SAFETY RELATED RECALL

Global Recall Action
Number: N759v5

Changes are highlighted in blue

| Subject: Range Rover (L405) Front Suspension Knuckle Crack | Publication No.: N759v5 |

E377524

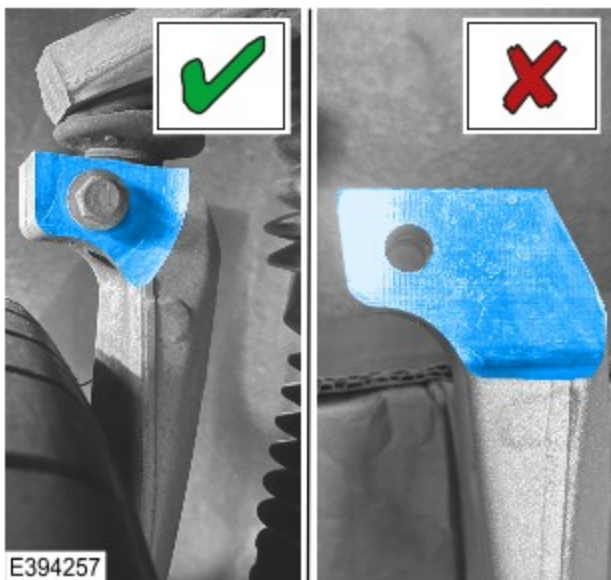
1. The illustration shows the front knuckle bracket components.

1. Front knuckle bracket side hooks.
2. Front knuckle bracket side hooks bolt.
3. Front knuckle bracket rear plate.
4. Front knuckle bracket rear plate bolts.

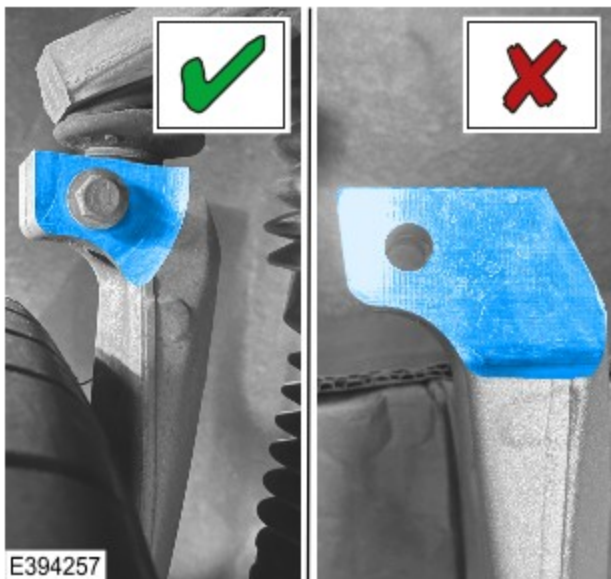
Inspect the front right wheel knuckle.

- If the front right wheel knuckle is the type shown in the illustration with the **GREEN ✓**, it has **PASSED** service inspection 1. No further action is required for the front right wheel knuckle, **continue to the next step**.
- If the front right wheel knuckle is the type shown in the illustration with the **RED X**, it has **FAILED** service inspection 1. **Continue to the next step**.

Inspect the front left wheel knuckle.

- If the front left wheel knuckle is the type shown in the illustration with the **GREEN ✓**, it has **PASSED** service inspection 1. No further action is required for the front left wheel knuckle, **continue to the next step**.
- If the front left wheel knuckle is the type shown in the illustration with the **RED X**, it has **FAILED** service inspection 1. **Continue to the next step**.

- If both the front left and front right wheel knuckles **PASSED** Service inspection 1, **do not continue with this campaign and release the vehicle.**
- If both the front left and front right wheel knuckles **FAILED** Service inspection 1, **complete Service inspection 2 for both the front left and front right wheel knuckles.**
- If the front left wheel knuckle **PASSED** Service inspection 1 and the front right wheel knuckle **FAILED** service inspection 1, **complete Service inspection 2 for the front right wheel knuckle ONLY.**
- If the front right wheel knuckle **PASSED** Service inspection 1 and the front left wheel knuckle **FAILED** service inspection 1, **complete Service inspection 2 for the front left wheel knuckle ONLY.**

E332627

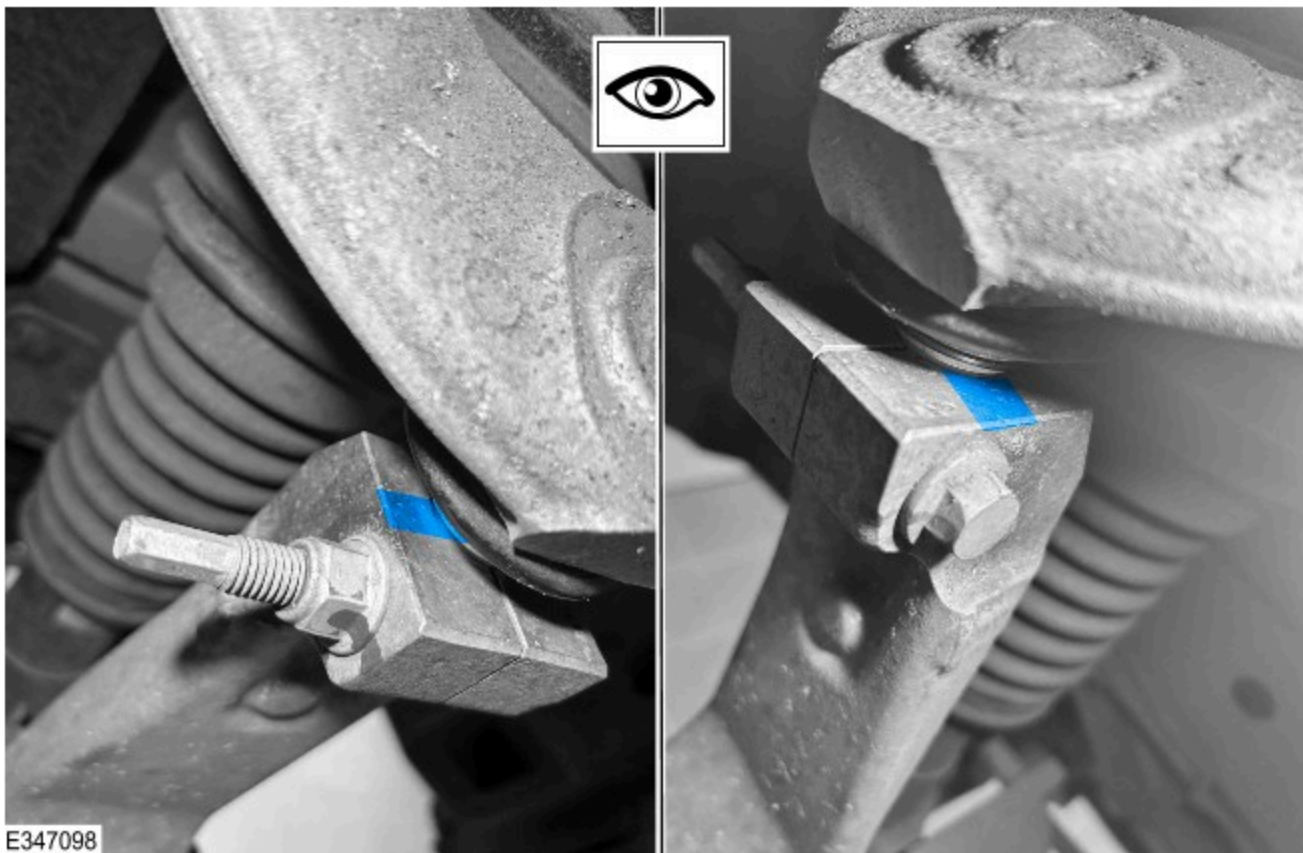
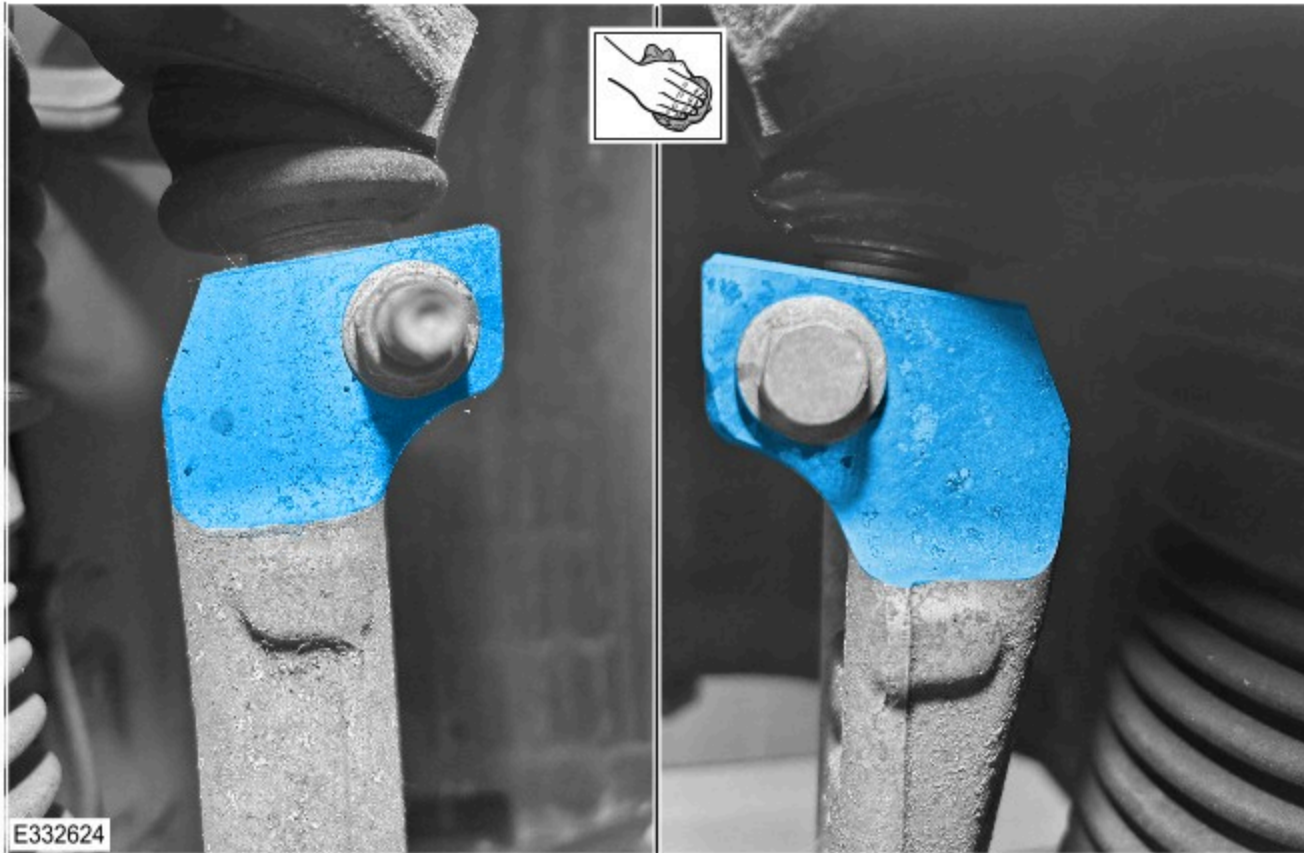
Examples of front knuckle cracks are shown in the illustrations.

- If cracks **ARE** visible on the front knuckle, the front knuckle has **FAILED** service inspection 2. Replace the front knuckle that has **FAILED** service inspection 2 (see TOPIx Workshop Manual section 204-01: Front Suspension - Removal and Installation - Wheel Knuckle).
- If cracks **ARE NOT** visible on the front knuckle, the knuckle has **PASSED** service inspection 2. **Continue to the FRONT KNUCKLE BRACKET INSTALLATION PROCEDURE.**

E373425

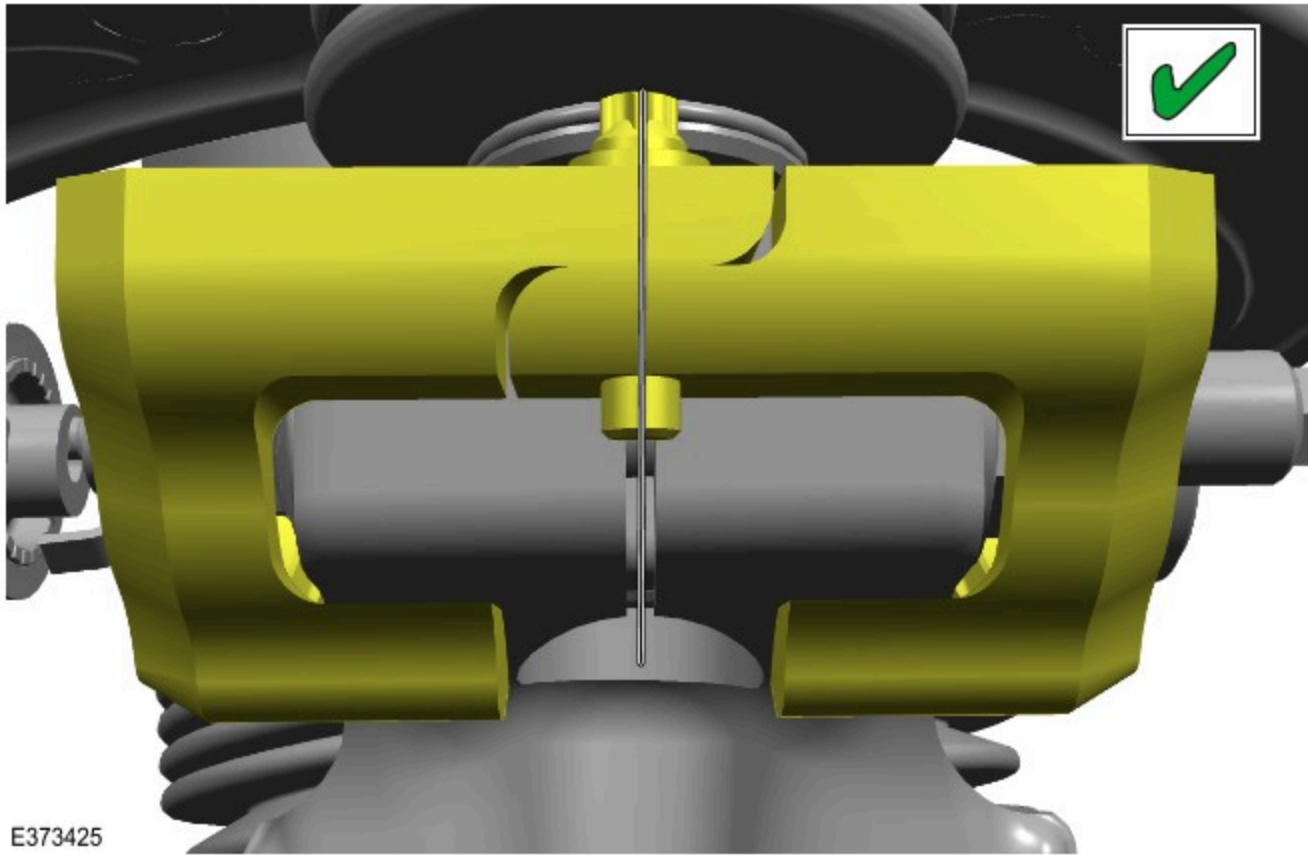
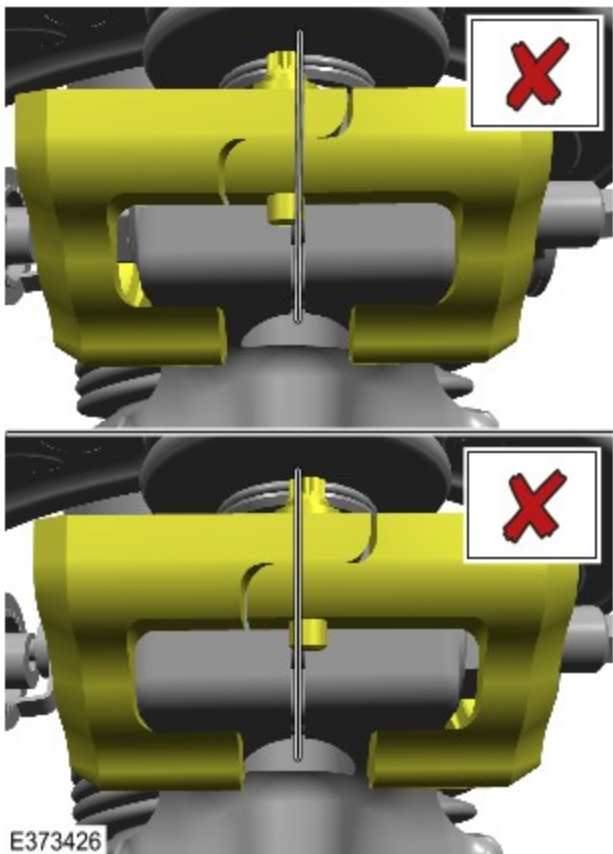
- The front knuckle bracket must be centrally aligned to the front wheel knuckle as shown in the illustration with the **GREEN** ✓.
- The front knuckle bracket must not be aligned to the front wheel knuckle as shown in the illustrations with the **RED X**.

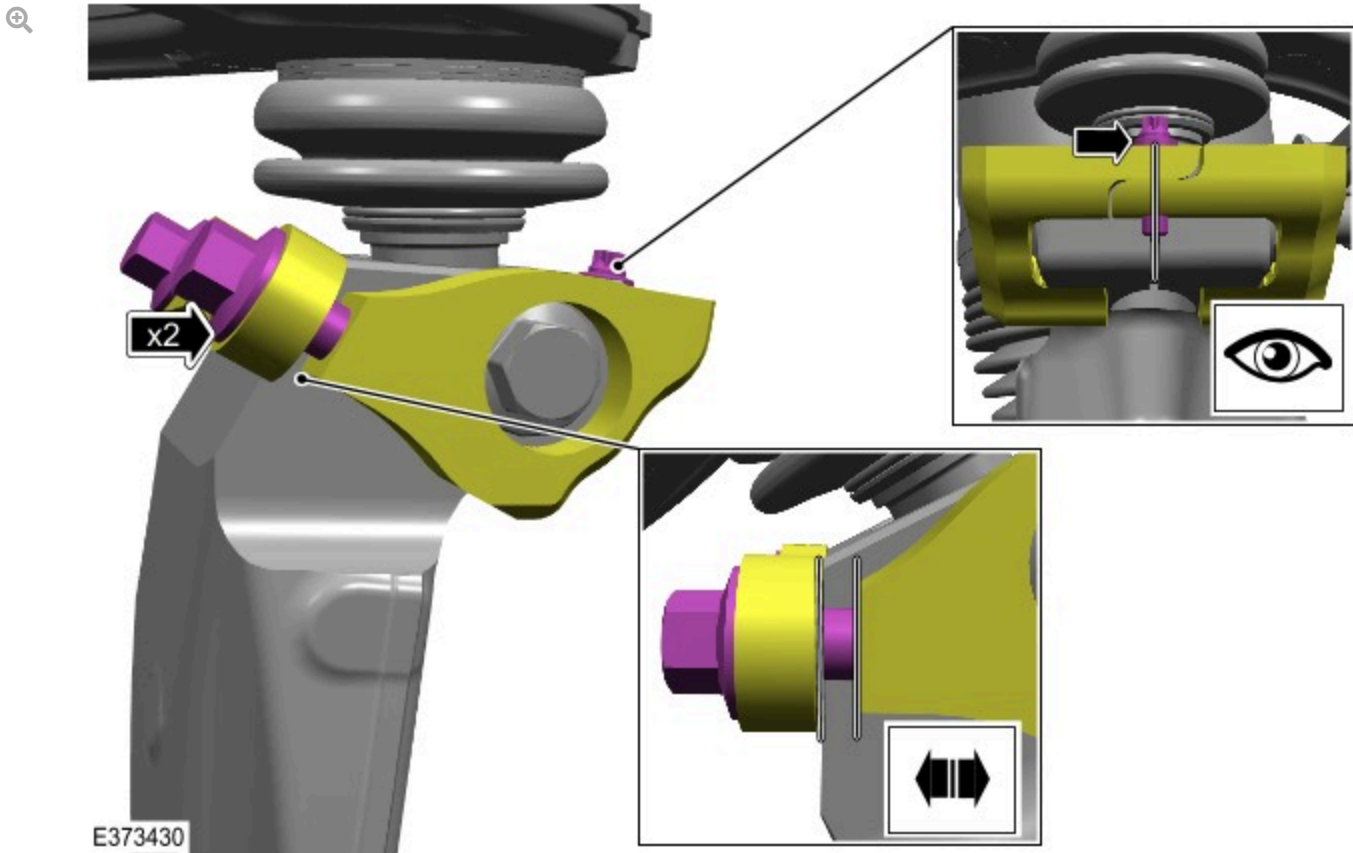
- There must be a gap between the front knuckle bracket rear plate and the 2 front knuckle bracket side hooks.
- The gap between the front knuckle bracket rear plate and the 2 front knuckle bracket side hooks must be maintained both sides of the front knuckle bracket rear plate.
- The front knuckle bracket must remain central to the front knuckle during tightening, as shown in the illustration.

Fully tighten the 3 front knuckle bracket bolts.

1. M5 Bolt: **6 Nm**
2. M8 Bolts:
 - Stage 1: **10 Nm**
 - Stage 2: **24 Nm**
